# Durban Waste to Energy Project

## PCF response to the revised Meth Panel recommendations

Sandra Greiner, Bob Chronowski, Johannes Heister – 11 July 2003

**Figure 1: CO2 emissions from using one kWh of electricity, based on total energy produced by Eskom power stations**

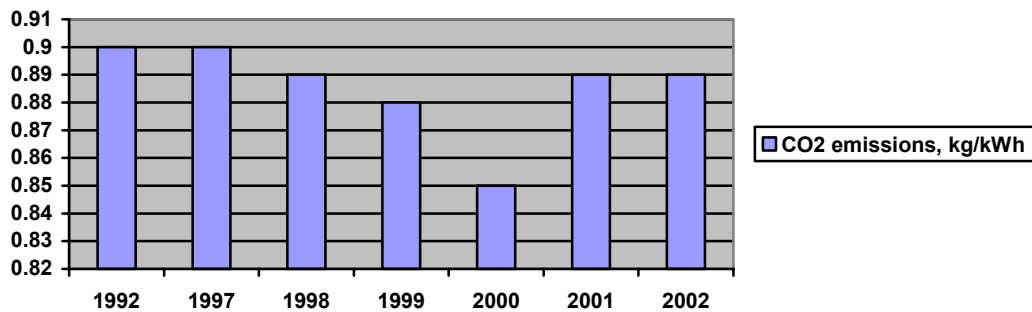
*Section 3.b:* The application of the methodology to South Africa tends to overestimate the baseline emission factor. The official utility statistics should be compared to independent studies for the same grid, verified again independent studies. So the methodology did not demonstrate that it has resulted in a conservative evaluation of CERs.

Part of the differences between the factor determined in the study and other factors quoted by the Meth Panel can be explained through differences in the **reference year**. The emission intensity of the South African grid has been fairly volatile over the past years (see table below), but only in one year in the last 10 did it get as low as 0.85 kg CO<sub>2</sub>/kWh. Due to the reactivation of moth-balled coal power plants and higher load factors on existing coal-fired plants, the emission intensity has gone up in recent years. **Please note that the methodology proposes to update the emission factor on a yearly retroactive basis taking into account the most recent data, as provided in Eskom's annual report. This way, emission reductions can be estimated accurately.**

The emission intensity of production of 1kWh of electricity reported by Eskom lies between 0.85 (2000) and 0.9 (1997). Thus, the official utility statistics do not provide a systematically higher emission factor than the independent studies referred to by the Meth Panel and the PCF has no reason to believe that the official utility statistics are not accurate.

However, in order to demonstrate conservativeness, the PCF agrees to use the production based emission factor published yearly in Eskom's annual report, which is comparable to the results of independent studies.
